## Construction Authorization

### Environmental Health Septic/Well Permit Diagram

\* Revised CA for Septic due to well re-location.

4-Bedroom Septic Layout  
Lot 37, Grandiflora Subdivision  
Franklin County, North Carolina

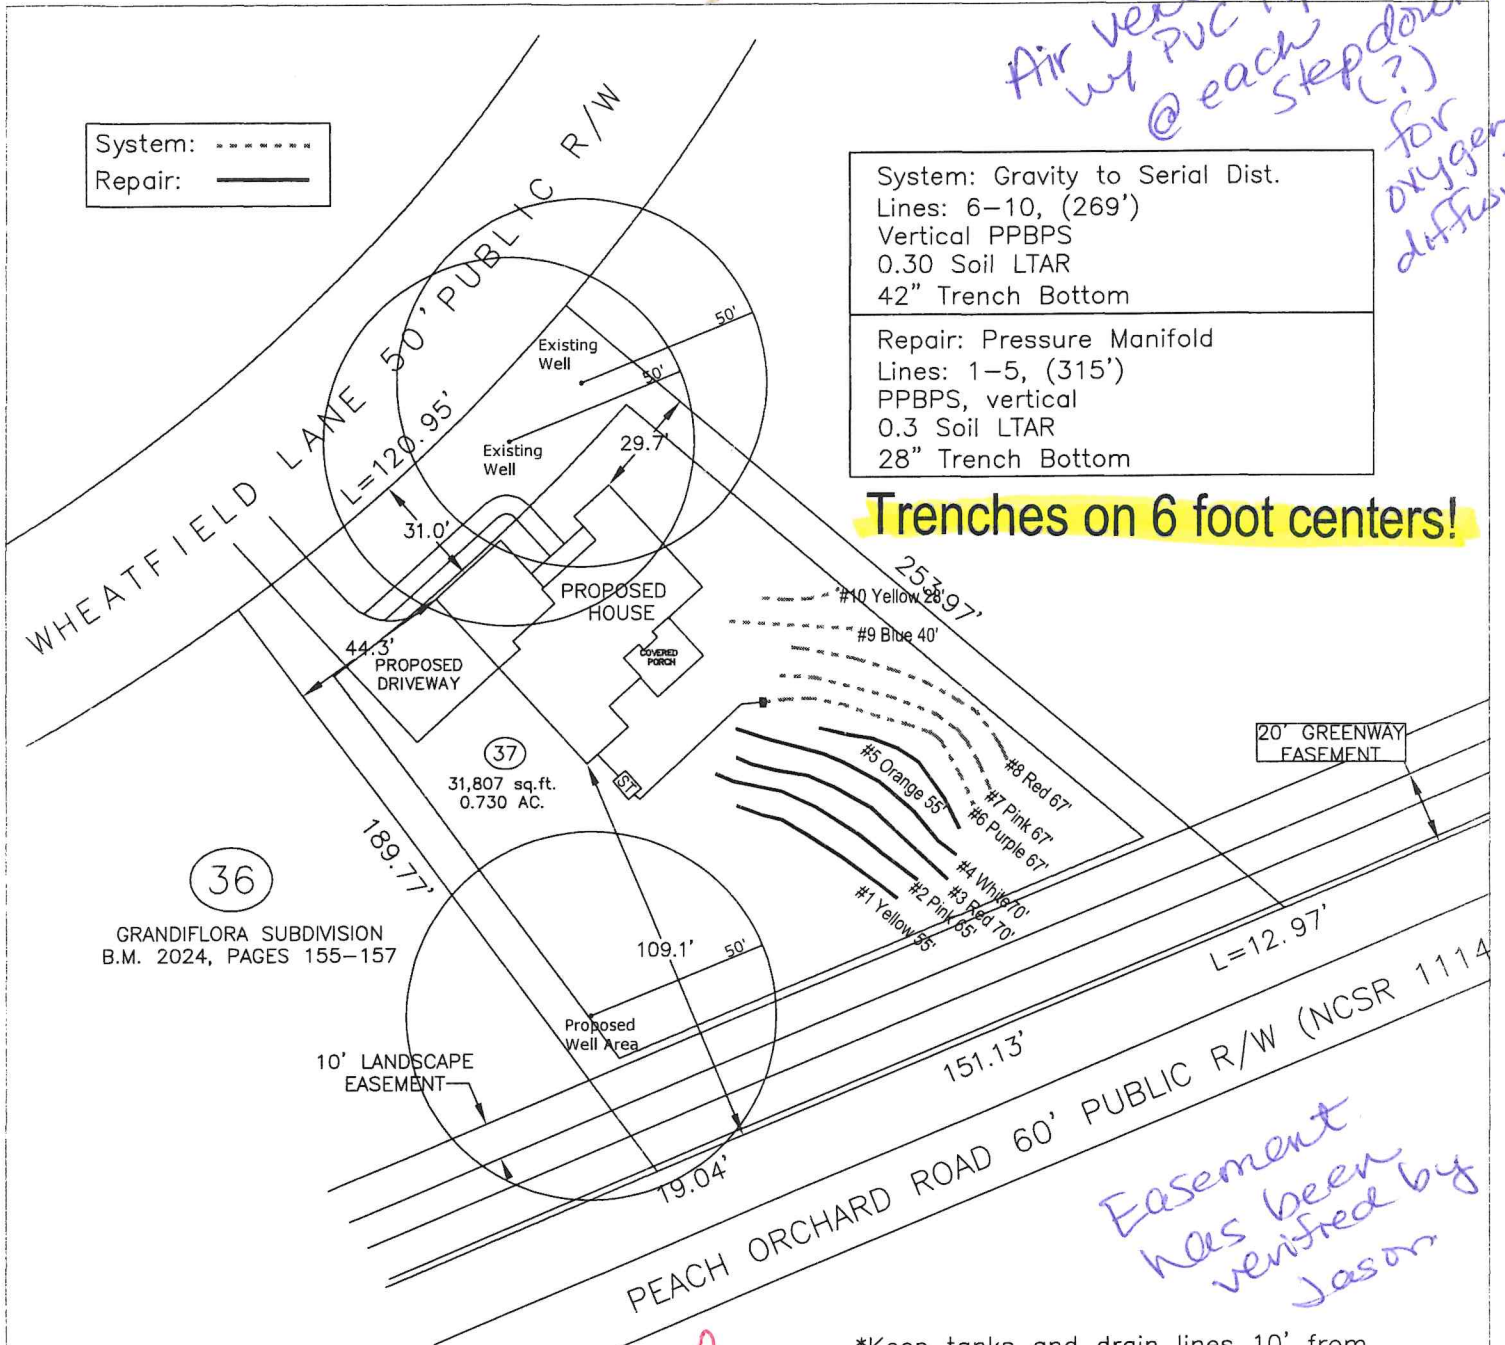
- Pits conducted for 42" install.

*Revised  
11-21-24*

System: Gravity to Serial Dist.  
Lines: 6–10, (269')  
Vertical PPBPS  
0.30 Soil LTAR  
42" Trench Bottom

Repair: Pressure Manifold  
Lines: 1–5, (315')  
PPBPS, vertical  
0.3 Soil LTAR  
28" Trench Bottom

*Air vents pipe  
w/ PVC pipe  
@ each stepdown  
(?)  
for oxygen  
diffusion*

**Trenches on 6 foot centers!**
